Access Compliance Report

Public Rights-of-Way

| Intersection ID: 47463 | Main Street: DOMINION_VILLAGE_DR | Cross Street: DOMINION_GREEN_DR | Location: NE |
| ADA ID: 2526E7D8E0E9 | Ramp Type: Perp | Initial Pass/Fail: Fail | Overall Compliance: No |

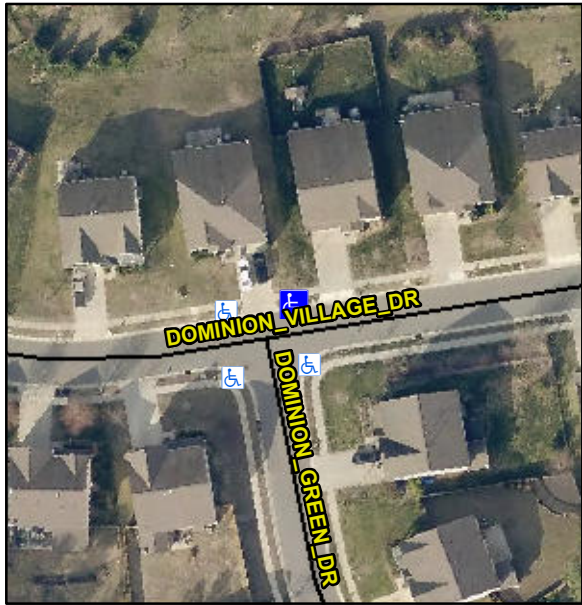
| | PROW/ADA: | | Not Found, R304.2.2, R304.5.3 | |

| Compliance | Description | Data | Compliance | Description | Data |
|------------|-----------------------|------|------------|-----------------------------|------|
| N/A | Ramp Length (in) | 48.0 | No | Ramp Slope (%) | 8.5 |
| Yes | Ramp Width (in) | 52.0 | No | Ramp XSlope (%) | 5.3 |

|  | Possible Solutions: | | Remove & Replace Entire Ramp. | |
